PRELIMINARY SITE GRADING CONSTRUCTION PLANS
FOR
HILLSIDE AT LORSON RANCH
EARLY OVERLOT GRADING / EROSION CONTROL PLANS

PROJECT:
HILLSIDE AT LORSON RANCH
LORSON BLVD AND WALLEYE DR
COLORADO SPRINGS, COLORADO

**COVER SHEET
EARLY GRADING AND
EROSION CONTROL PLAN**

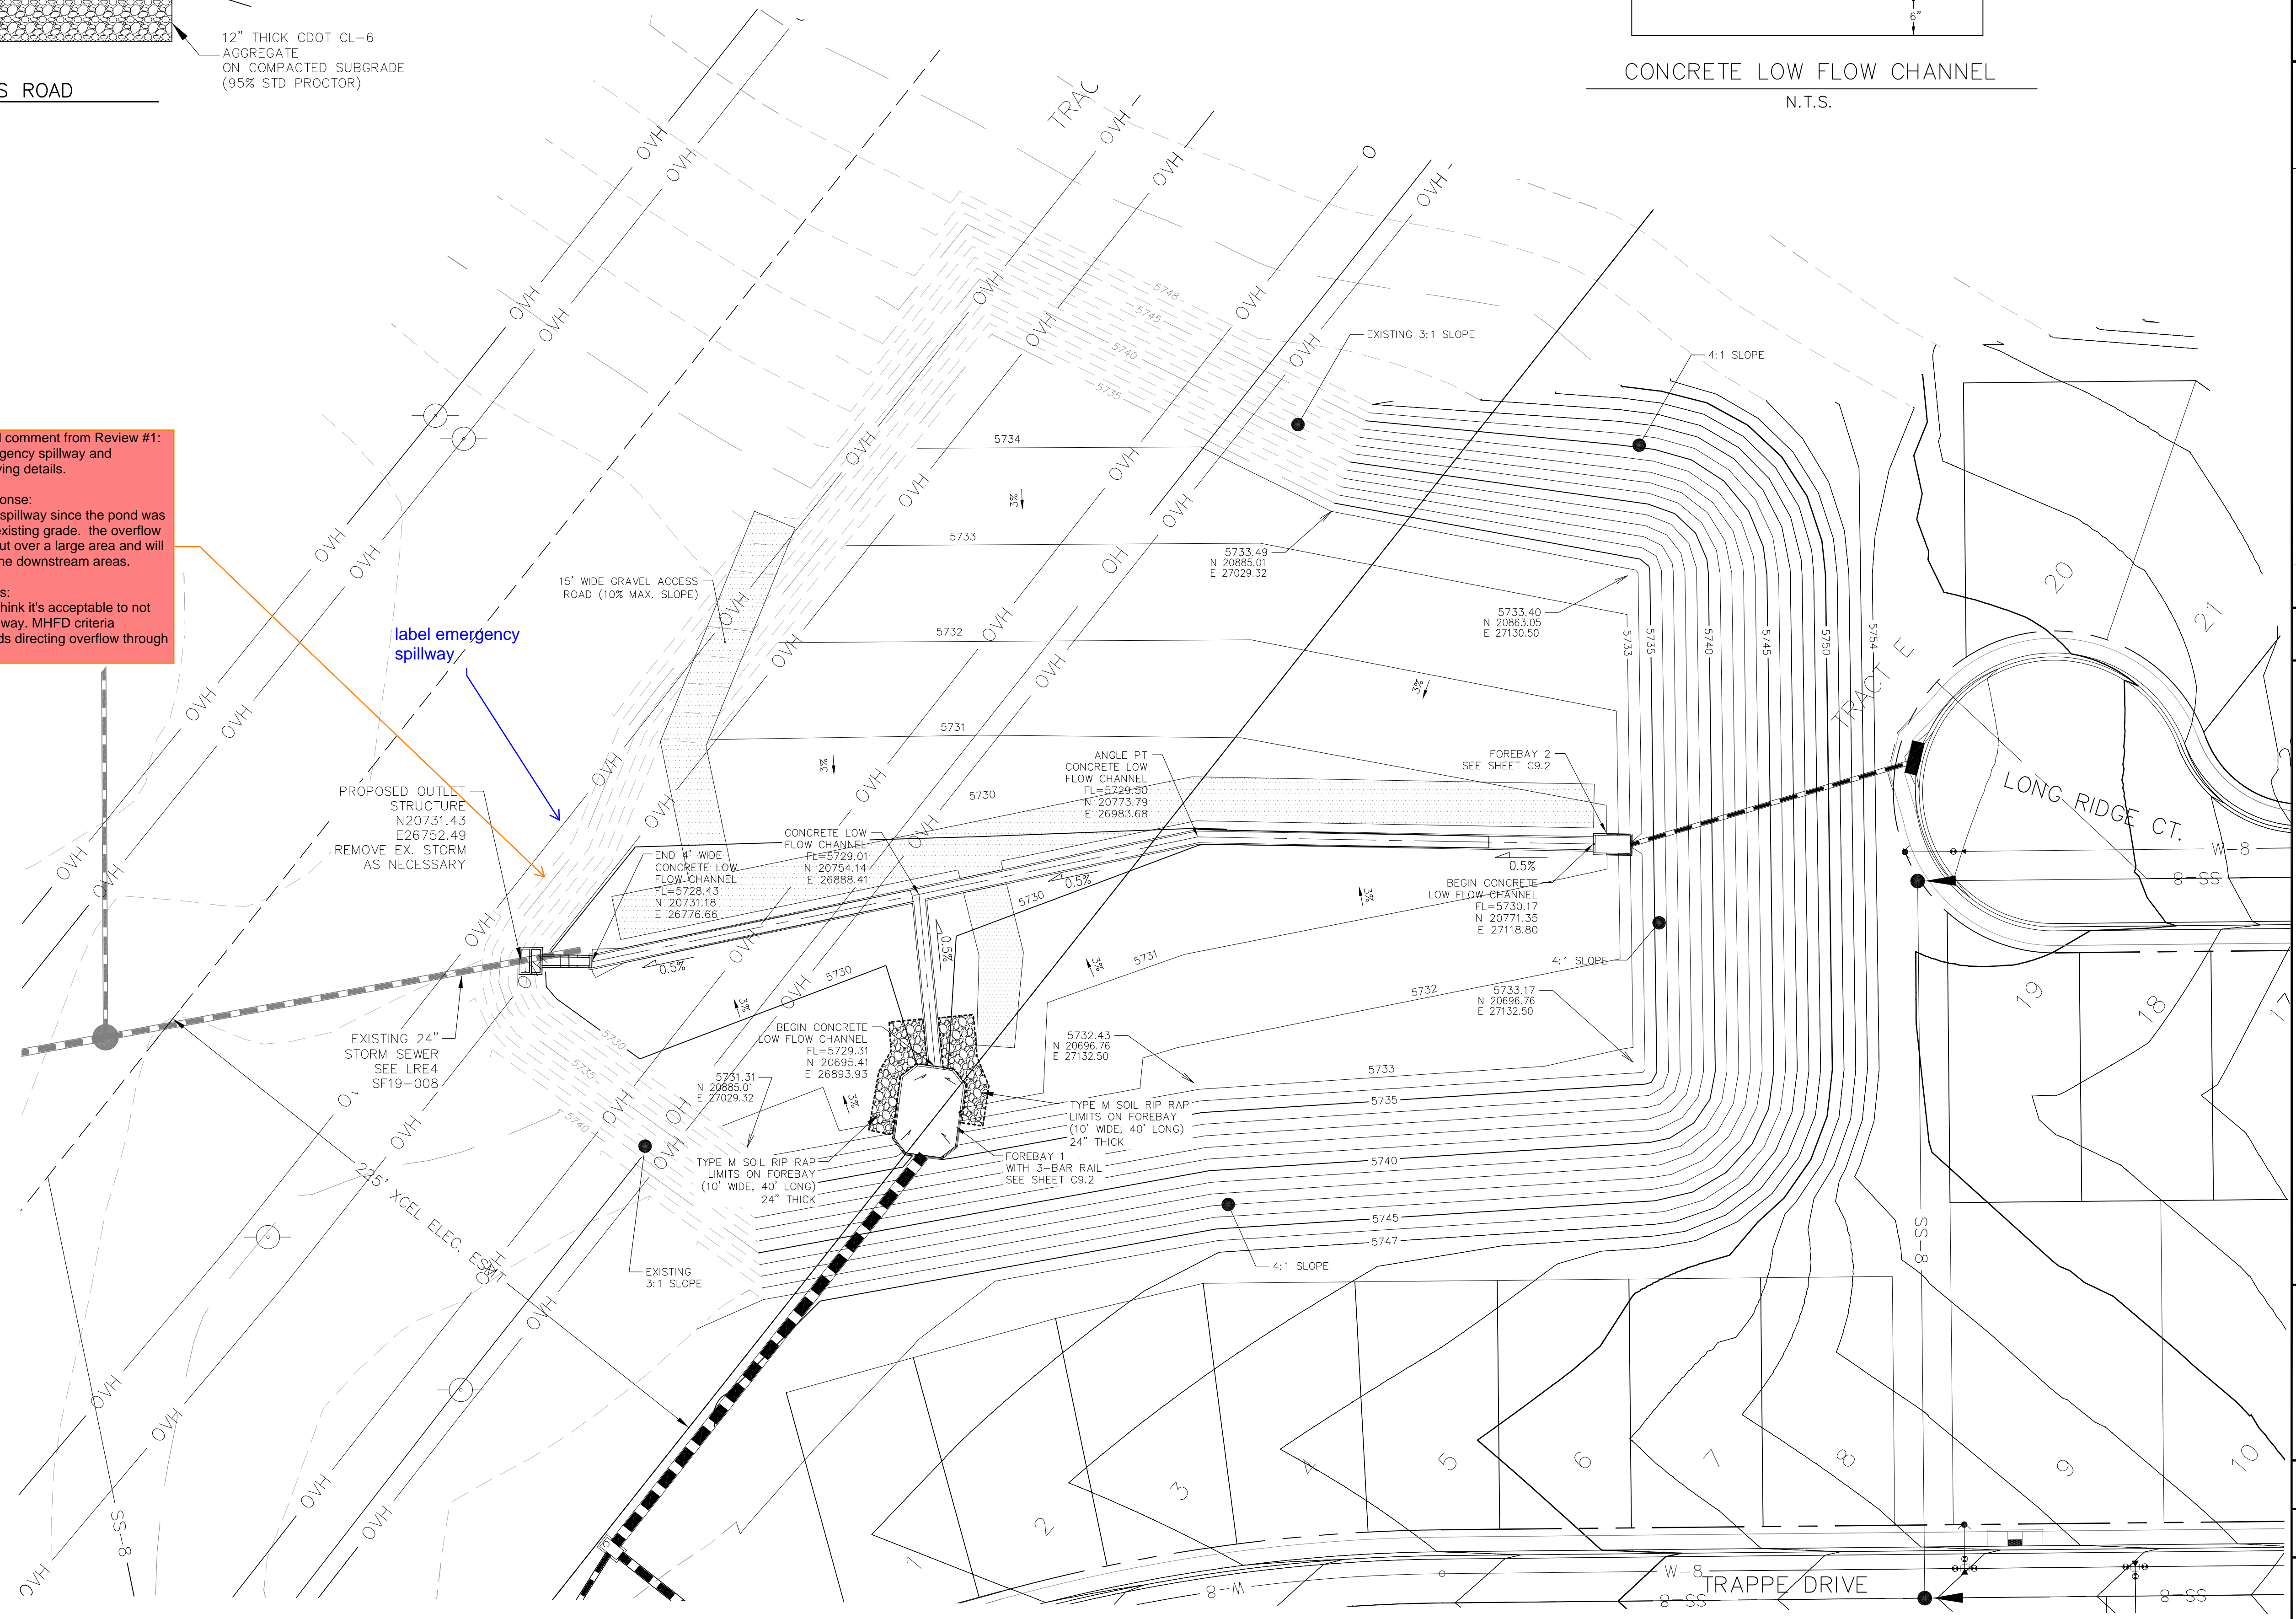
Unresolved comment from Review #1:
 show emergency spillway and accompanying details.

My thoughts:
 I still don't think it's acceptable to not have a spillway. MHFD criteria recommends directing overflow through a spillway.

label emergency spillway

Rich's response:
 there is no spillway since the pond was cut below existing grade. the overflow is spread out over a large area and will not erode the downstream areas.
